**TOWN OF NEWBURGH  
PLANNING BOARD  
TECHNICAL REVIEW COMMENTS**

**PROJECT: RAM HOTEL, INC.**  
**PROJECT NO.: 16-21**  
**PROJECT LOCATION: SECTION, 97, BLOCK 2, LOT 37**  
**REVIEW DATE: 27 AUGUST 2018**  
**MEETING DATE: 6 SEPTEMBER 2018**  
**PROJECT REPRESENTATIVE: MECURIO-NORTON-TAROLLI-MARSHALL**

**Survey & Subdivision**  
for Lands of  
**Newburgh Auto Park, LLC**

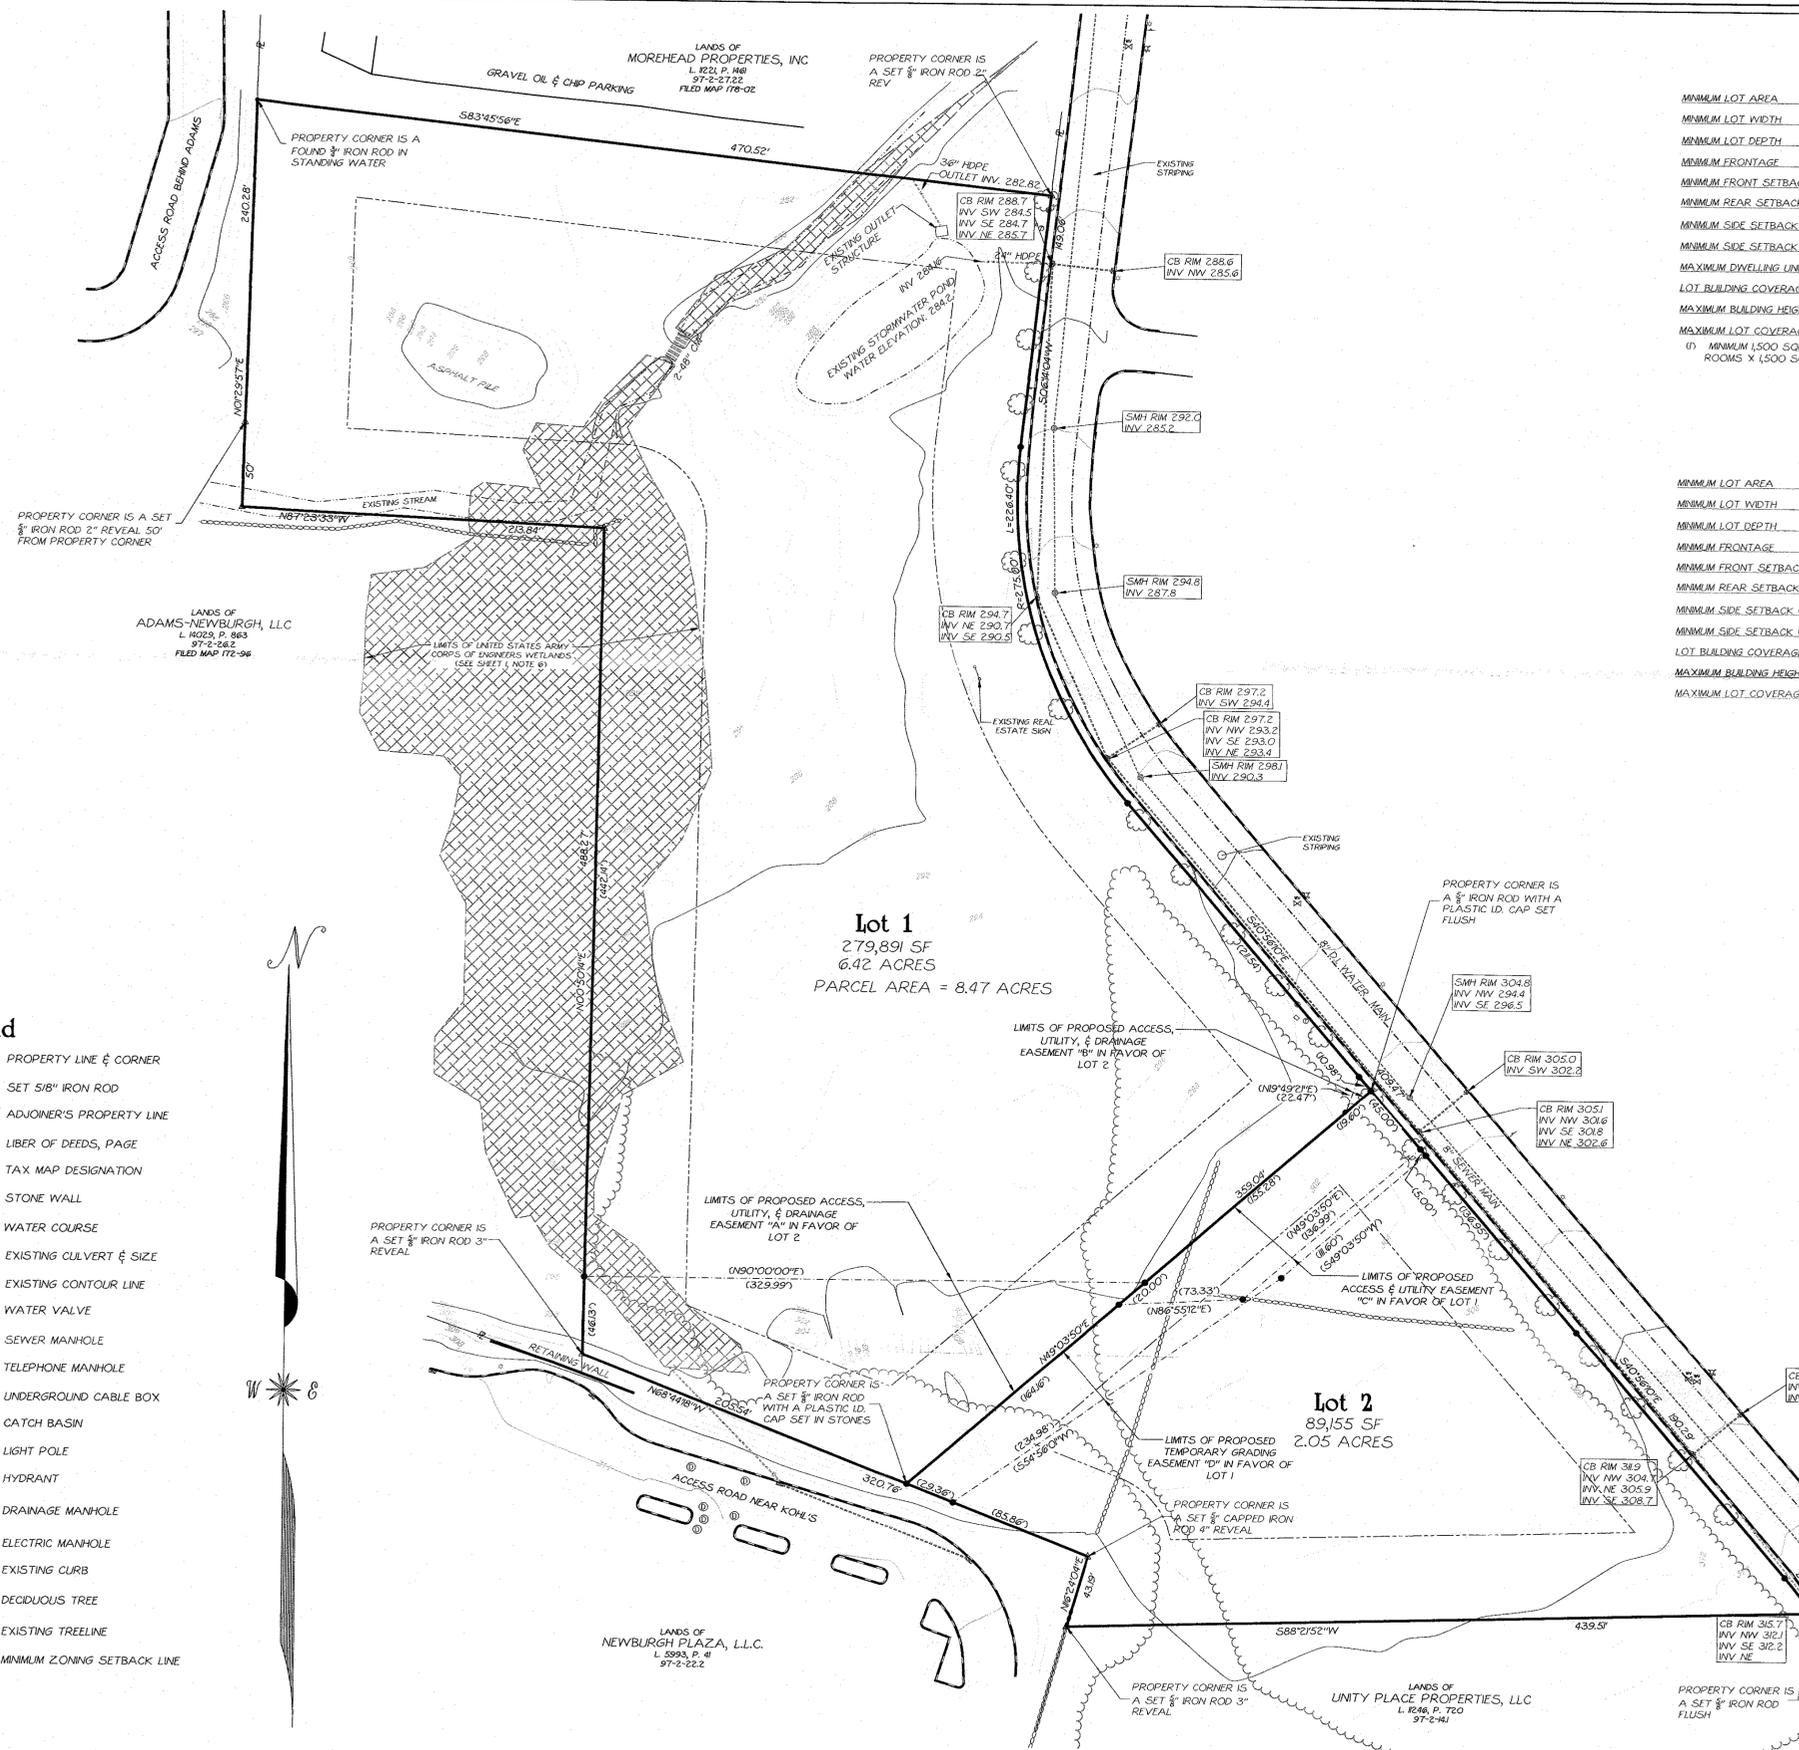
1. US Army Corps of Engineers jurisdictional determination of the wetland boundary referred to on Sheet 1 Note 6 should be received.
2. Plans have been revised to limit any additional wetland encroachment on the mapped wetland area. Revised building square footage, building location and retaining walls have been added to the plans to reduce the footprint of the site. The southerly access road from Unity Place has been shifted to be more on the proposed adjoining lot.

8. The Subdivision plan Sheet 1 or 1 has been revised depicting limits of access and utilities easement being located further onto proposed Lot #2. A concept plan depicting a 9,375 sq. ft. office building has been provided for Lot #2. Parking calculations should be provided supporting the 50 parking spaces serving the potential office building use. The Bulk Table for the potential development Lot #2 identifies maximum building height as 40%, this should be revised.

### Segmental Retaining Wall Section

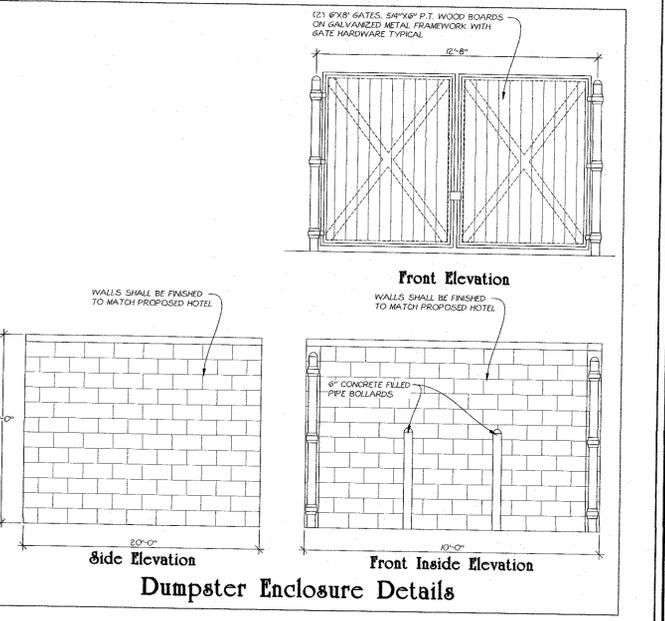
6. Karen Arent's comments regarding modifications to the landscape plantings should be received.
7. Segmented block retaining wall approximately 10 ft. high have been proposed. These will require submission of stamped design drawings at Building Permit. Wooden guide rails have provided at all retaining walls and at the north end of the site in proximity to the bio retention area.
